LOCA Aspects of the Combustion Engineering Advanced Light Water Reactor — System 80 +

Question 720.6

Loss of Offsite Power Event Tree

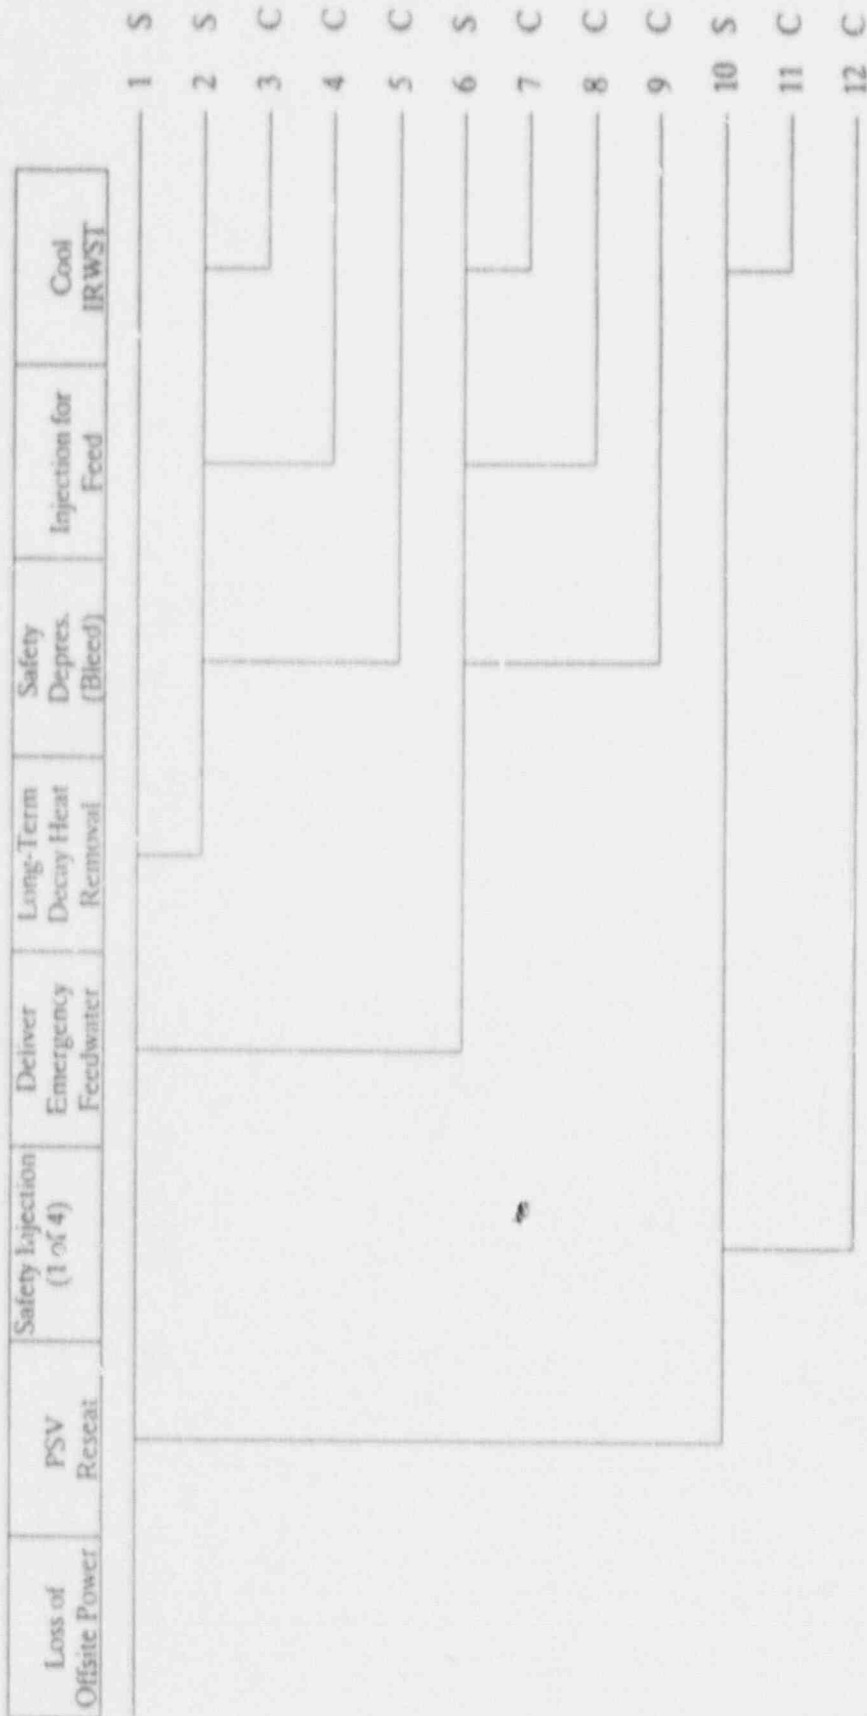
On page B-67 of the CESSAR, Appendix B, it is stated that "failure of a PSV to reseal after the primary side pressure decreases will result in a small Loss-of-Coolant Accident (LOCA) with offsite power unavailable. This is considered to be a small LOCA initiator for quantification of small LOCA frequencies." Essentially identical statements are also made on page B-144 for Tornado strike sequence analysis. Were these sequences actually transferred to the small-LOCA event tree? If so, what are their frequencies?

The statements regarding PSV LOCAs following a LOOP or tornado strike initiator are incorrect. These "consequential" small LOCAs were treated within the appropriate event trees as shown in figures B3.1.8-1 and B4.2.3-1 (presented here for convenience). The statements on pages B-67 and B-144 were inadvertently left in from a previous iteration of the PRA. C-E is in the process of updating the System 80+ PRA and these statements will be deleted.

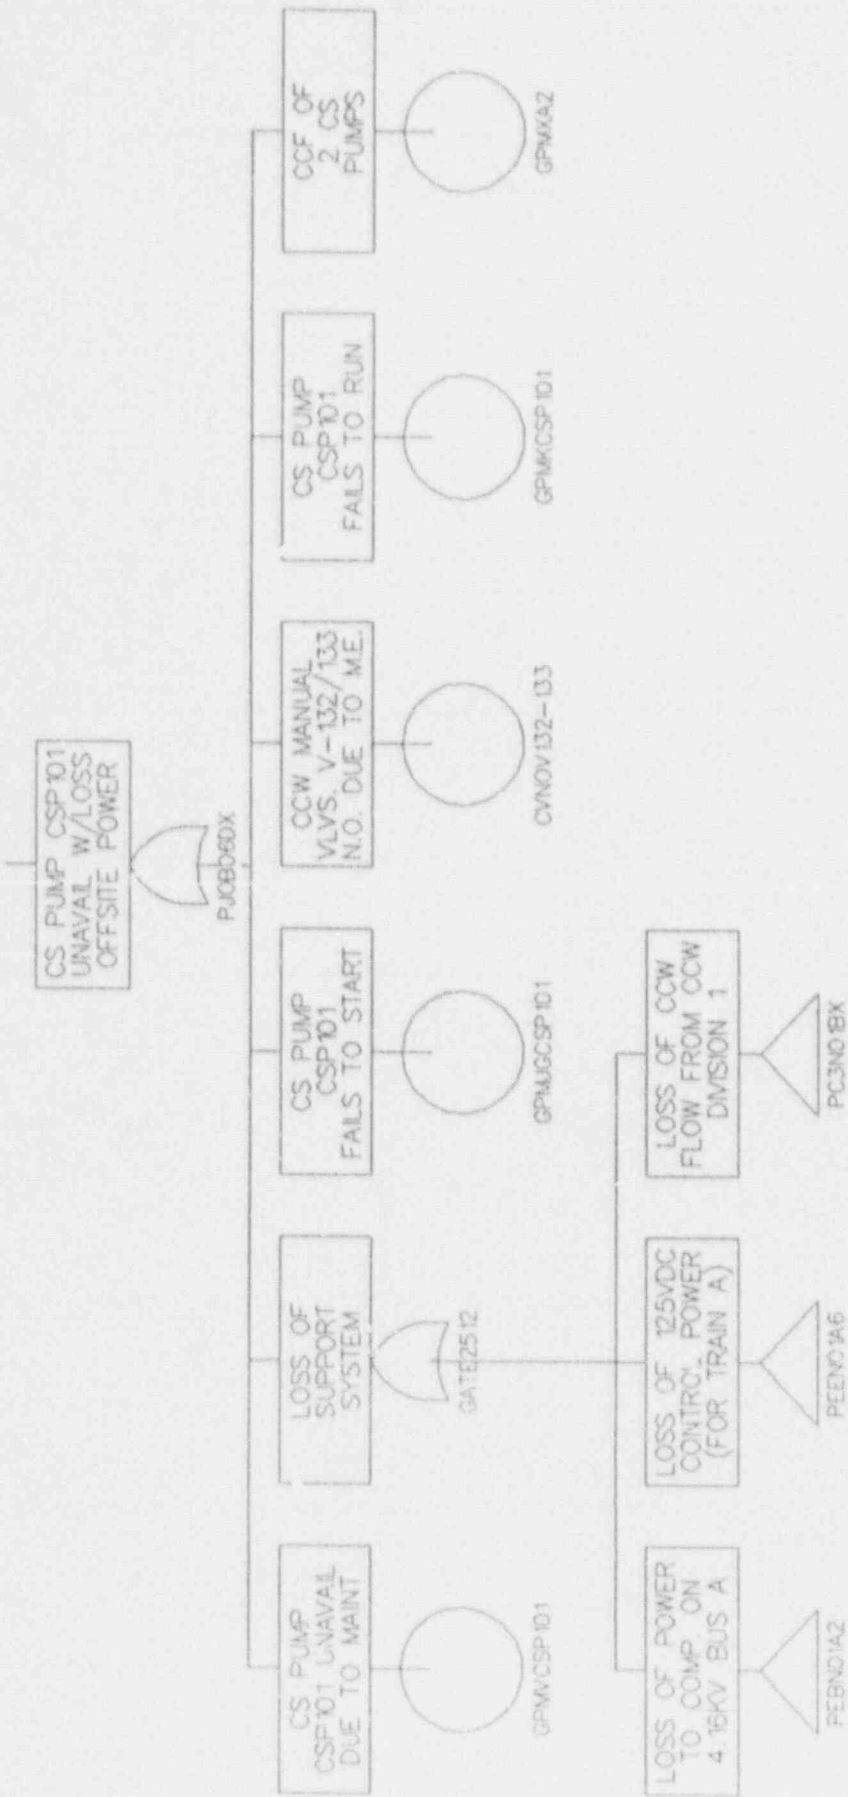
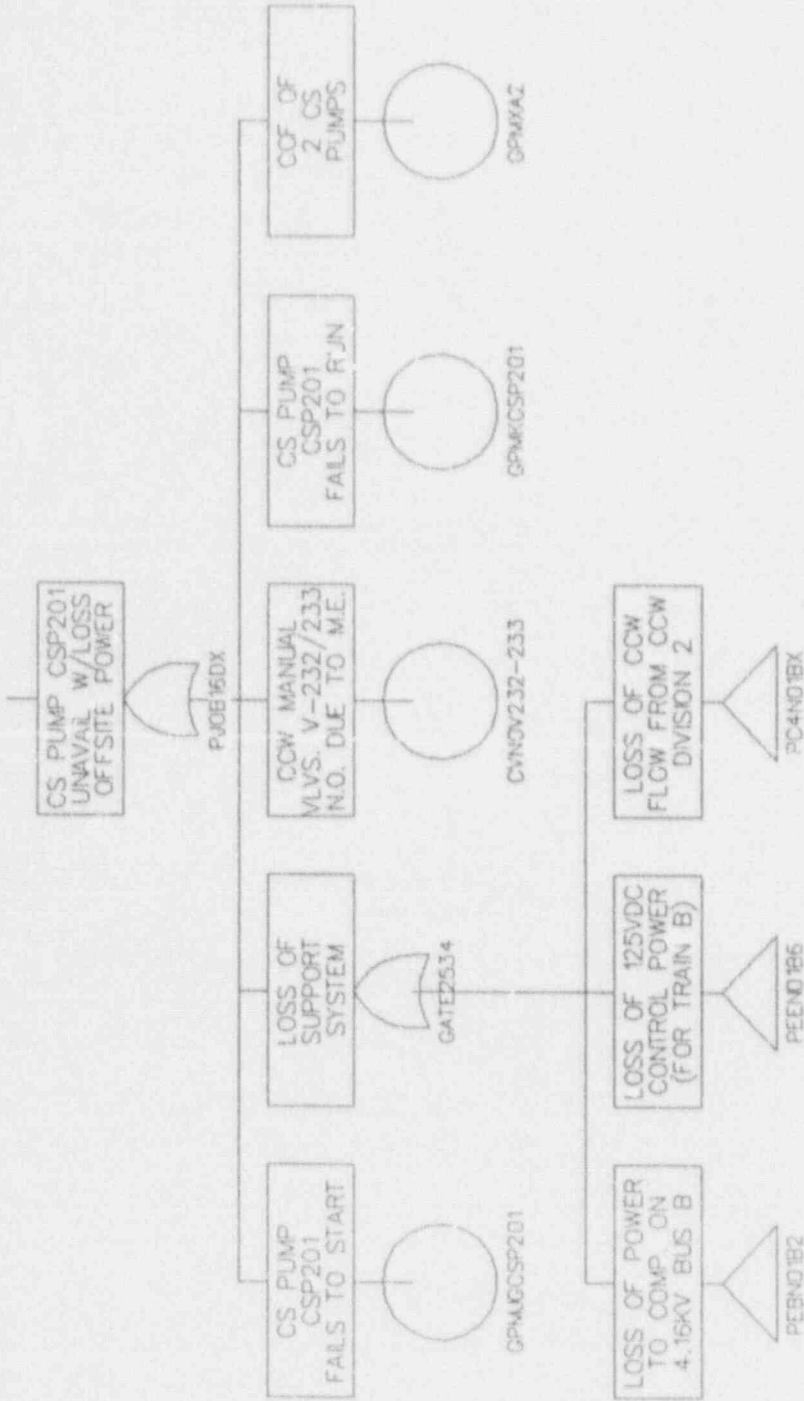
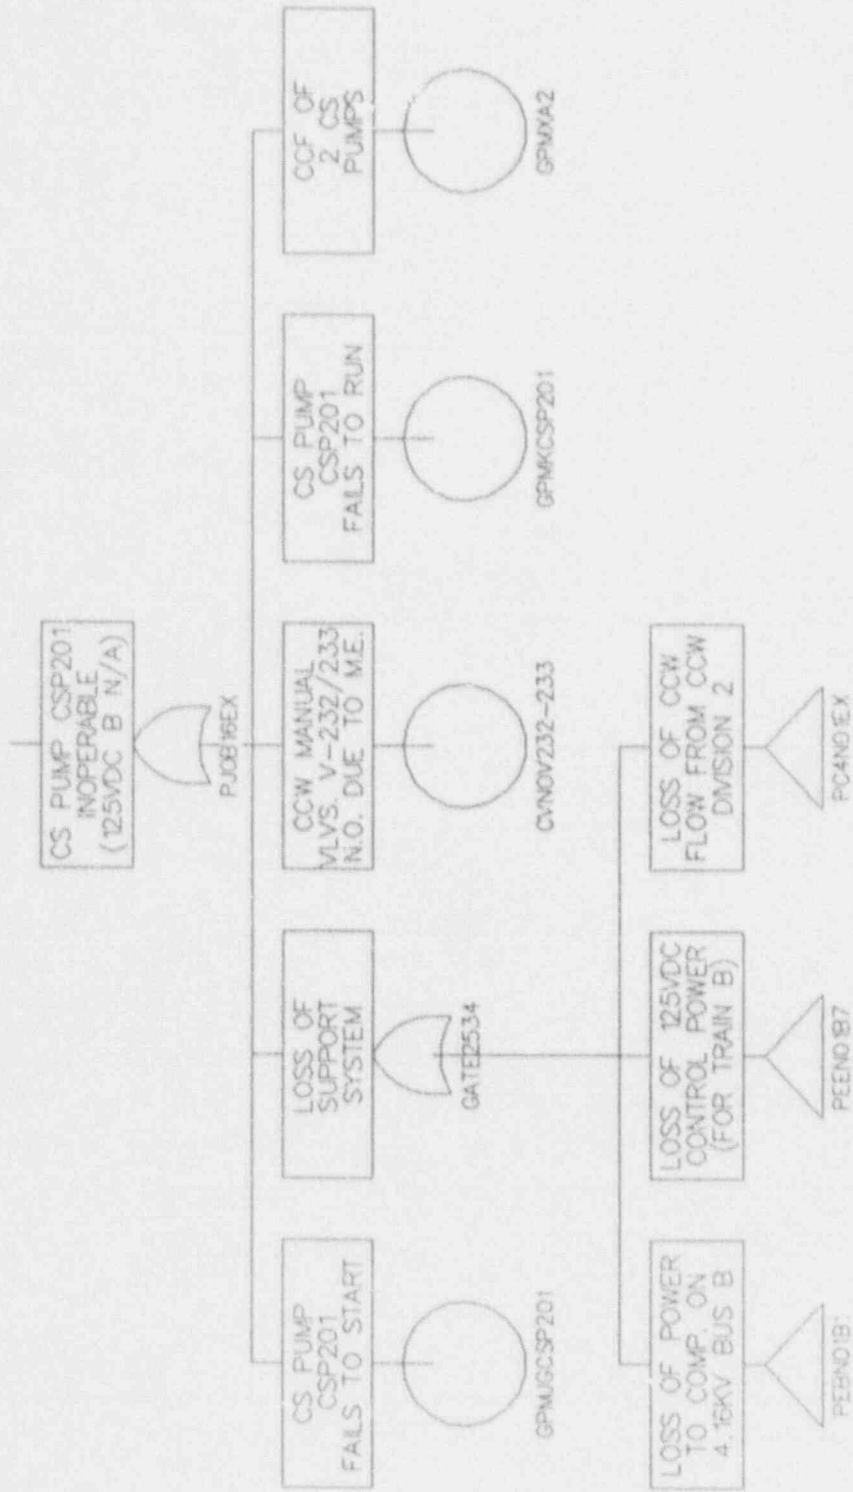
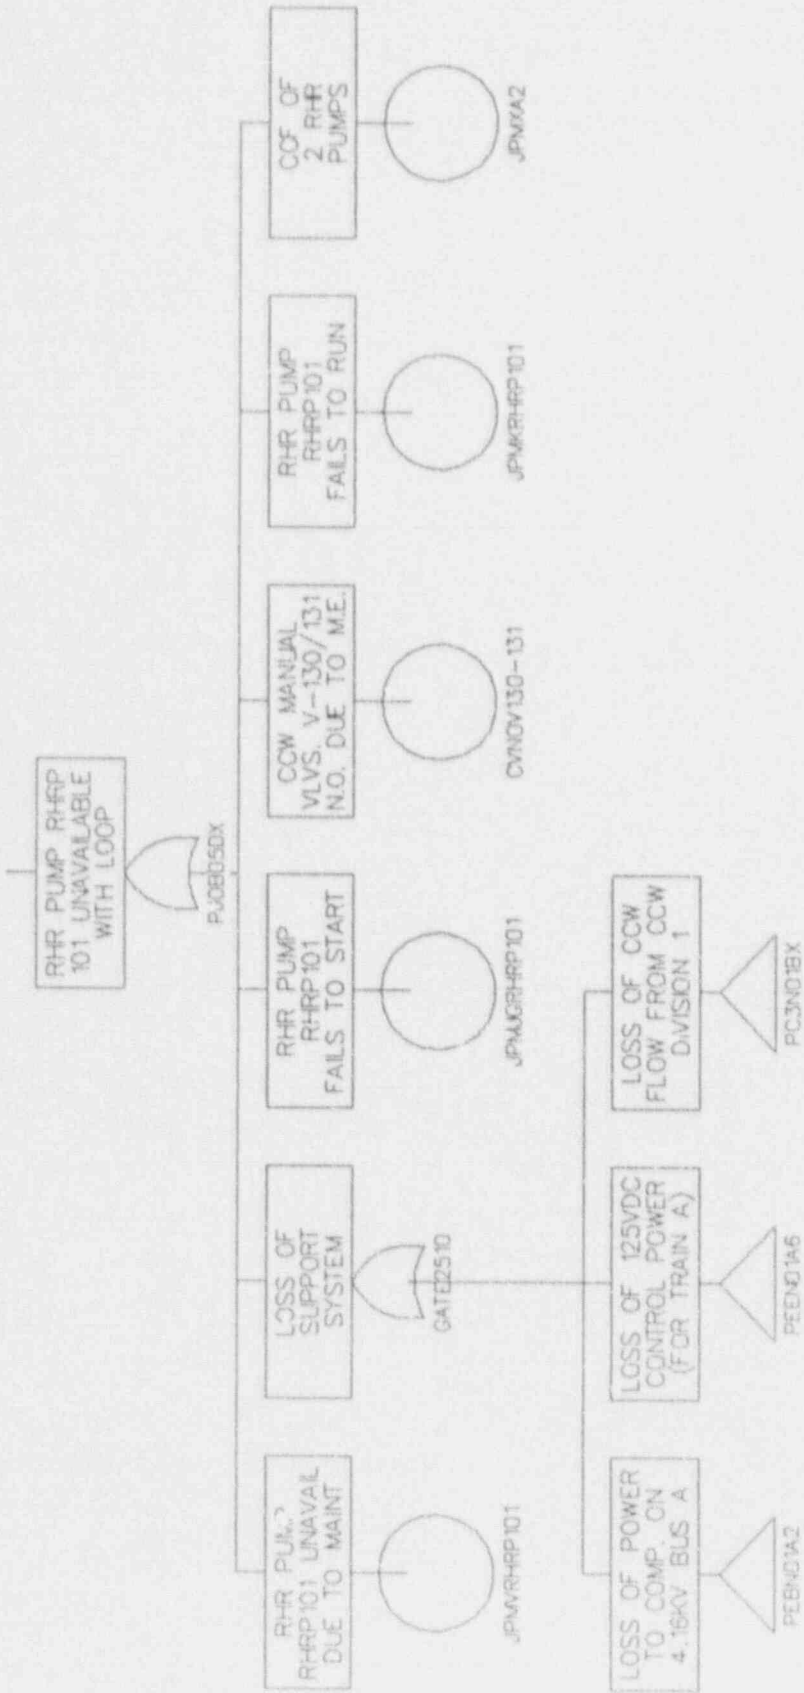
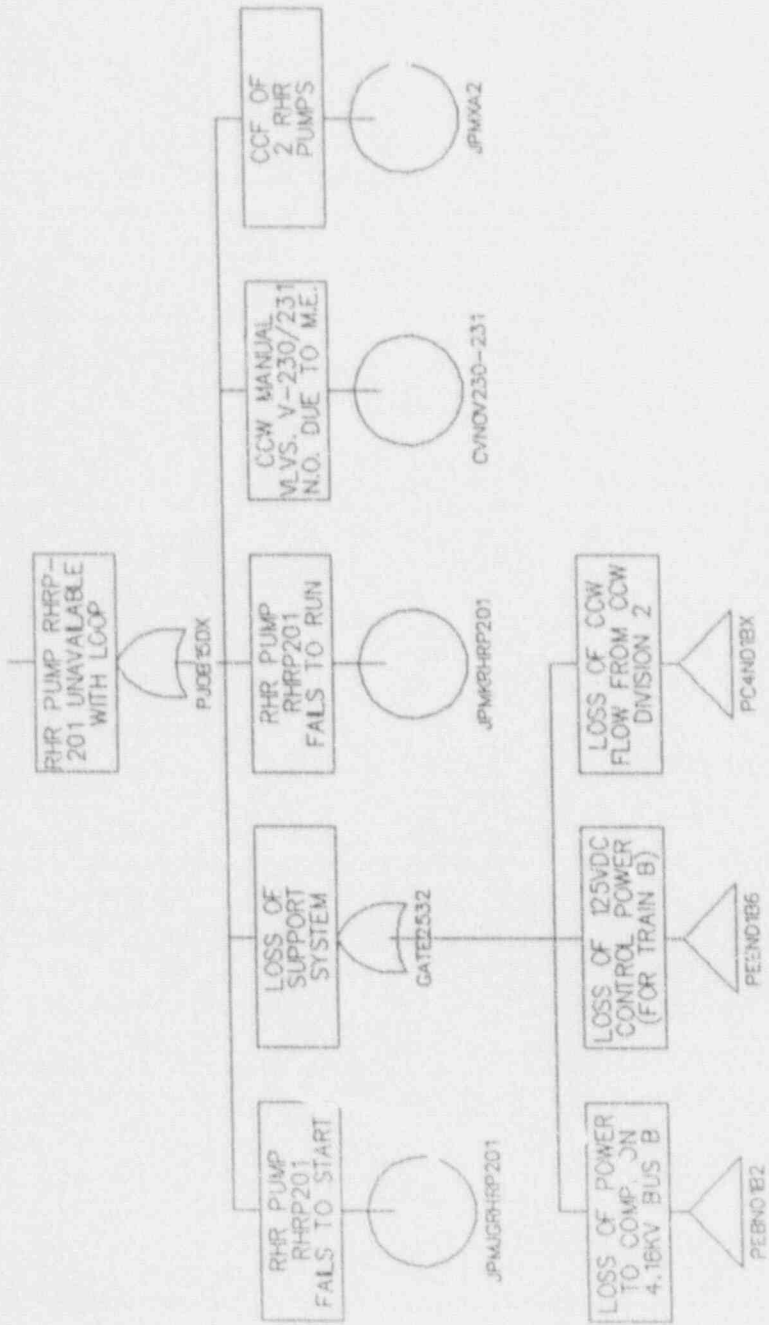
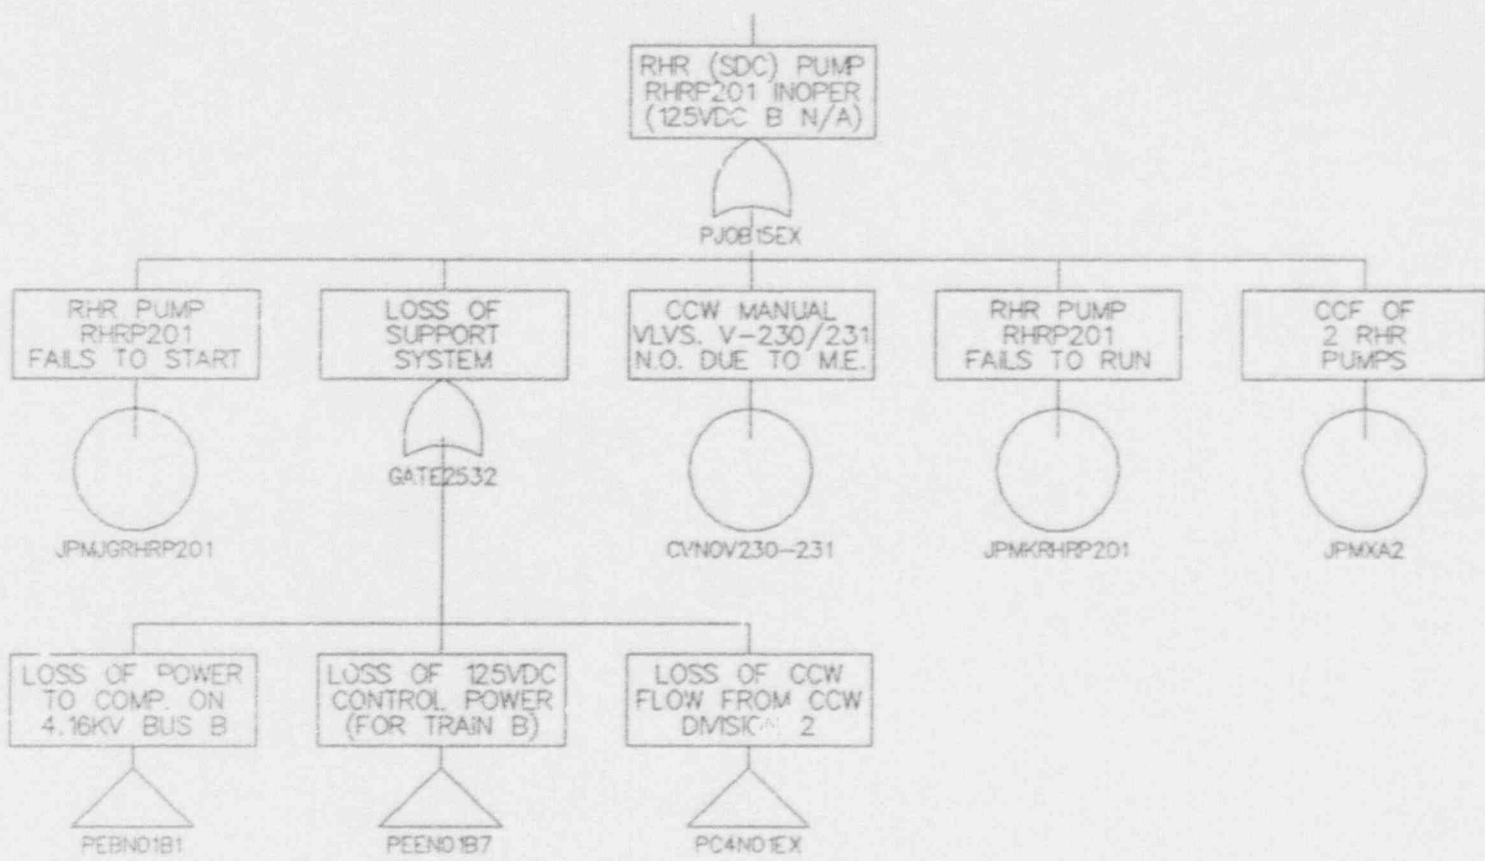
Loss of one component cooling water division, loss of 125 Vdc vital bus, or loss of a 4.16 KV vital bus all have some impact on the availability of the containment spray system. No clear treatment of the relevant impacts, however, can be found in the fault trees (Figure 6.3.13-2) developed for failure of the containment spray system. Please explain why they are not modeled.

The fault tree developed for unavailability of RHR pump-101 given loss of a component cooling water division is presented as PGIB14CX in Figure 6.4.2-7 (on page 6-845).

Also, it is to be noted that, as described in subsection 6.3.1.1.3.11 and depicted in Figure 6.3.1-2, the 125 VDC class 1E power system consists of six independent and physically separate load groups. Each load group includes a battery, a battery charger and DC distribution center. The battery chargers of load group channels A, C and division I are powered from division I of the 480 VAC power system. Similarly, the battery chargers of load group channels B, D and division II are powered from division II of the 480 VAC power system. Furthermore, the ESF equipment which is loaded on the 4.16 KV or 480 V bus is provided with redundant trip coils. Control power for the trip coil circuitries is assumed to be obtained from the 125 VDC buses A and I for division I equipment and from 125 VDC buses B and II for division II equipment. The CS and RHR pumps in train B are powered from division II power system, thus the control power for these pumps can be from 125 VDC bus B or II. Therefore, in the event of a failure of 125 VDC bus B, these pumps do not necessarily become unavailable. For the CS or RHR pump to completely fail, failure of both the 125 VDC buses B and II must occur. The fault trees, PJOB16EX and PJOB15EX, developed for unavailability of CS pump and RHR pump, given loss of a 125 VDC bus B, correctly model such logic.
